The Sizewell C Project

9.124 Comments on Responses to SZC Co.'s Responses to the ExA's Second Written Questions (ExQ2)

October 2021

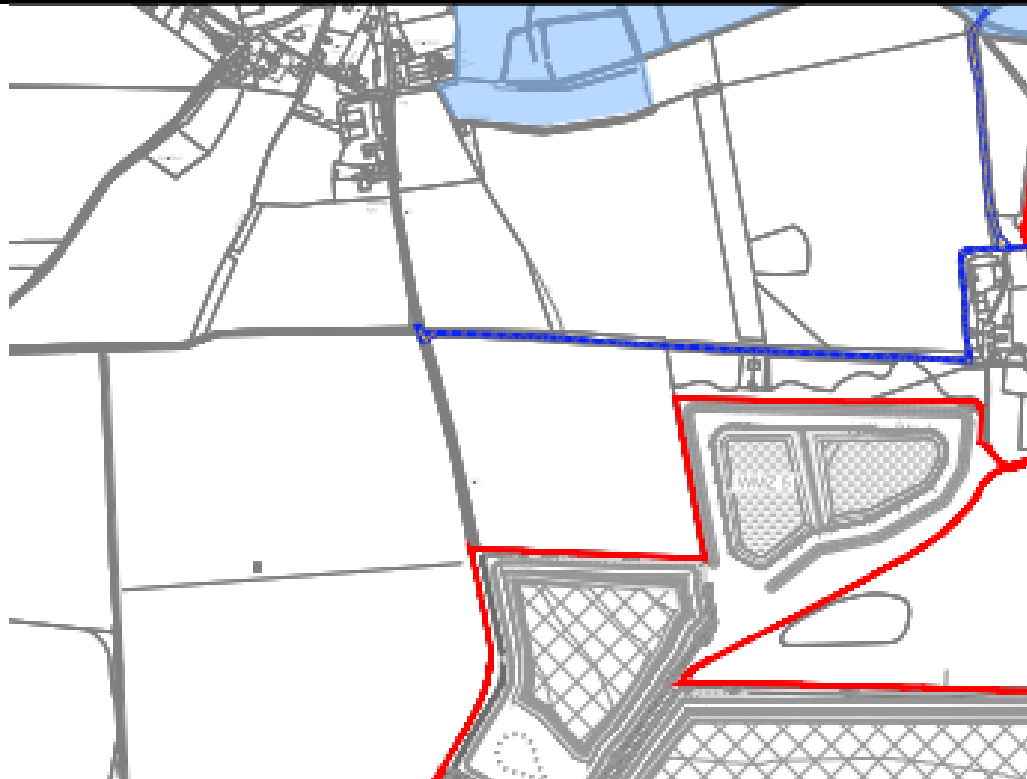
As shown on the plate above, the existing access runs east to Lower Abbey farm from the lane just south of Eastbridge and then runs north to access the southern edge of the Minsmere reserve. This access is entirely outwith the proposed order limits and so access will be unimpeded by the temporary construction area of Sizewell C which occurs to the south.

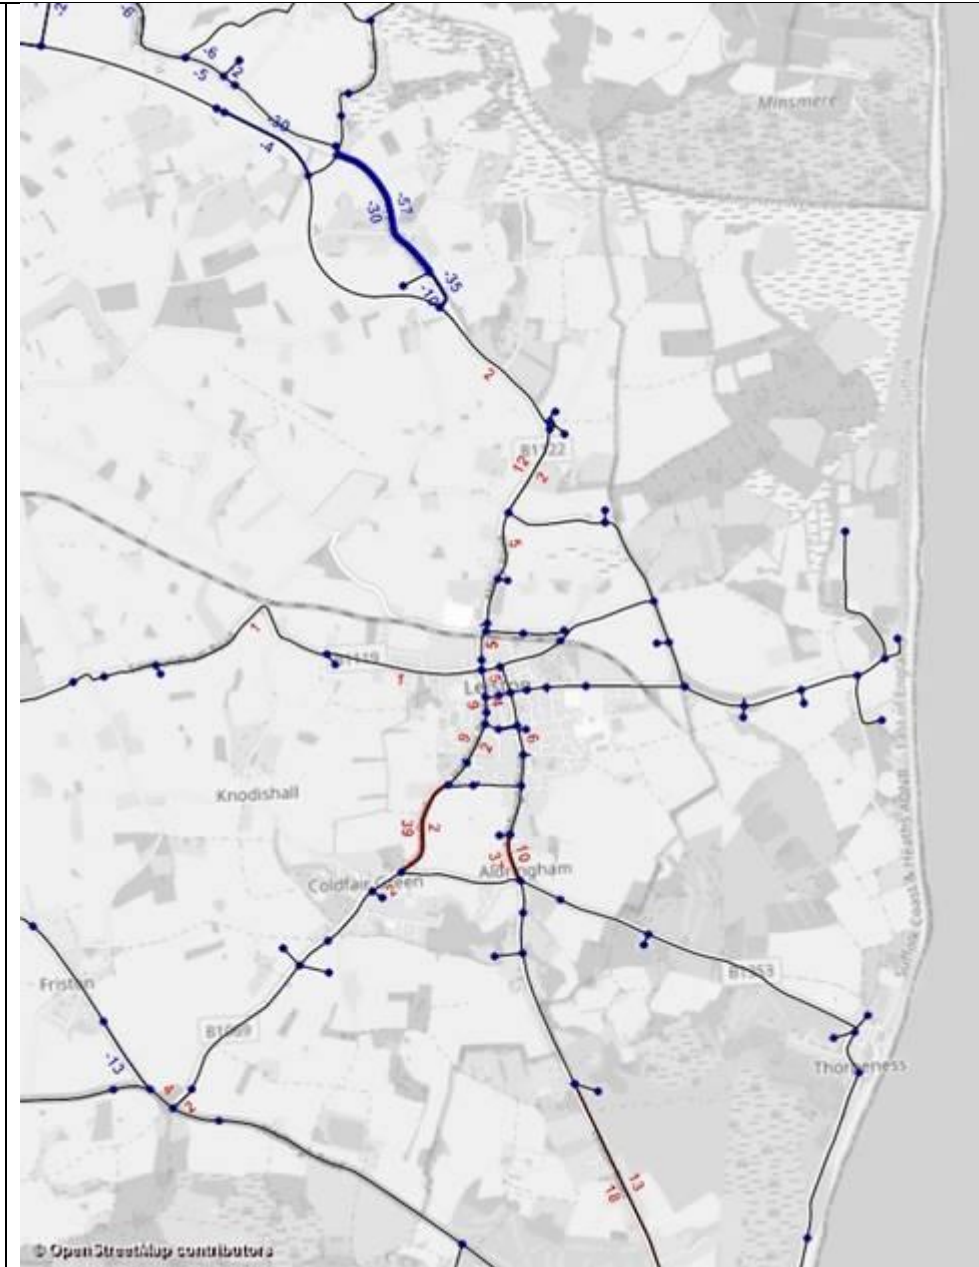
ExQ2	Question to:	Question:
		<p>assessed already as part of the DCO. The diagram shows the following increase in flows in the Leiston area compared to what has already been assessed:</p> <ul style="list-style-type: none">- B1122 north of MDS roundabout +2 two-way veh/hr- Abbey Road south of MDS roundabout +14 two-way veh/hr- Abbey Road south of Lover's Lane +5 two-way veh/hr- B1122 Aldeburgh Road +6 two-way veh/hr in Leiston, +13 two-way veh/hr at Aldringham and +31 two-way veh/hr between Aldringham and Aldeburgh- B1069 in Leiston +11 two-way veh/hr, +41 two-way veh/hr north of Coldfair Green, +2 two-way veh/hr south of Coldfair Green- A1094 at the junction with B1069 +2 to +4 two-way veh/hr <p>The maximum increase in traffic generated by a double outage compared to the highest flows already assessed is +41 veh/hr north of Coldfair Green, which is less than 1 veh per minute increase.</p>
